Advice on Environmental Impact Statement – Toga Central – SSD-33258337

Thank you for your correspondence dated 25 August 2022 inviting the City of Sydney (the City) to comment on the Environmental Impact Statement (EIS) submitted for the Toga Central development at 2-8A Lee Street, Haymarket.

Figure 2: Ground floor plan (left) and Levels above ground level (right) with area of concern outlined in green

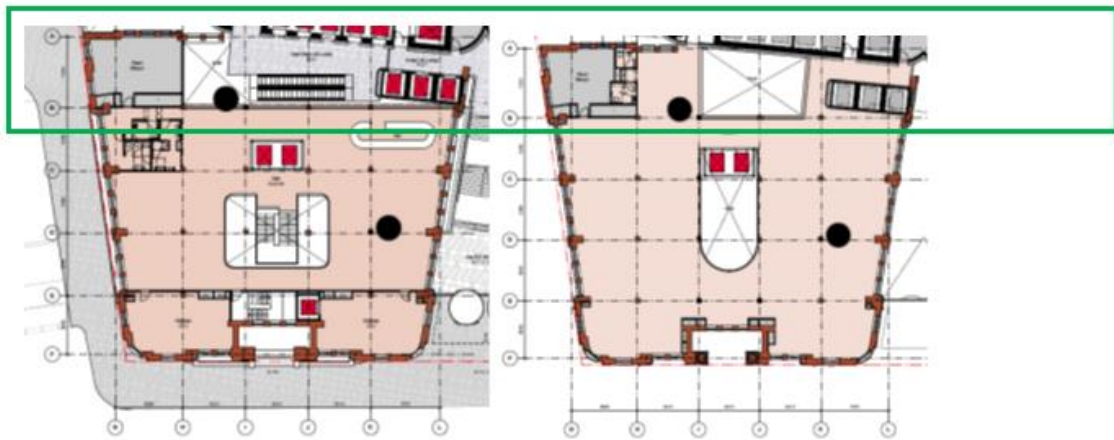
Of particular concern is the quantum of insertions proposed within the building between Grids A and B (see Figure 2 below), which reduces the floor plates to a fragmented series of passageways. The plant room, column, void and lift core result in almost total demolition of the floor plates in this area

In particular, the proposed escalators are not supported as they alter the historic character of the building. Additionally, the demolition of fabric raises concerns of the potential risk of damage to significant internal detailing of the stucco of the internal columns.

The amount of internal demolition and subsequent fragmentation of each level of the former Parcel Post building should be reduced. To conserve the character and spatial integrity of each floor level, it is recommended that:

- Consideration should be given to whether the proposed escalators and the lift core comprising three lifts servicing up to Level 19 between Grids K and L would be better relocated into the southern pod from a heritage perspective.
- The extent of insertions between Grids A and B should be minimised.
- A specific heritage asset construction methodology should be required to review the current proposed construction methodologies and to detail mitigation measures to limit potential risks to the internal columns and finishes.

Figure 3: Proposed tree removal plan (Landscaping and Public Domain Report)

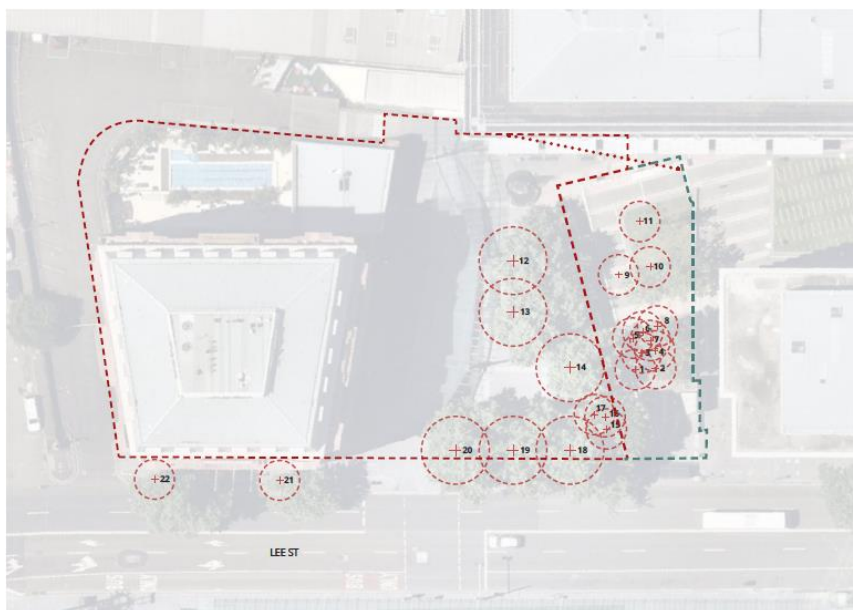
However, the City does not support the removal of Trees 18-22 (*Platanus x acerifolius* - London Plane Trees), which are noted as being of high retention value in the AIA.

Trees 18-20 are located adjacent to the Lee Street frontage in an area that is to be retained as public domain. The location of the trees adjacent to a site boundary generally makes tree retention more feasible than trees located centrally within the site.

Trees 21 and 22 are street trees located within the Lee Street road reserve. The Landscape Report outlines that these trees are proposed for removal as they will limit construction access and are not a suitable species due to being constrained between the heritage facade and the road. The City does not agree with these assertions. The trees have developed a slight phototropic lean away from the building and have been pruned early in their development for building and pedestrian clearances. With additional pruning works and protection, construction access is achievable. The crowns of the trees are not restricted on the roadside, and it is commonplace for street trees to have an asymmetrical crown form to accommodate a building on one side. Therefore, the removal of these large, healthy community assets is not supported by the City.

Further, the AIA does not provide an adequate assessment of the impacts on Trees 21 and 22. The Report notes that Trees 21 will be subject to a 'medium impact' and Tree 22 will be subject to a 'high impact' with no further details provided on what these impacts are. A more detailed assessment of impacts (noting that the existing heritage building within the Tree Protection Zones is to be retained) is required.

Trees 21 and 22 are street trees and together with Trees 18-20, they form a row of single species along the Lee Street frontage which provides significant shade and amenity to the site. They also provide the existing context for the frontage of the heritage building behind. It should also be noted that the existing street trees (also *Platanus x acerifolius* - London Plane Trees) adjacent to the Dexu Frasers site are proposed to be retained, maintaining the continuous row of healthy, mature trees along the Lee Street frontage.

- The removal of Trees 18-22 are not supported by the City. Design modifications are recommended to allow for their retention.

- A more detailed assessment of impacts to Trees 21 and 22 is required. Reference should be made to Clauses 3.3.4 of Australian Standard 4970 Protection of trees on development sites (2009).
- An increase in the soil volume on the site is required. The Arborist Report and the Landscape Plans need to be modified to ensure sufficient soil depth and volume is provided.
- The Landscape Report is to be updated to clearly show the percentage of proposed canopy coverage and outline adequate soil volumes.
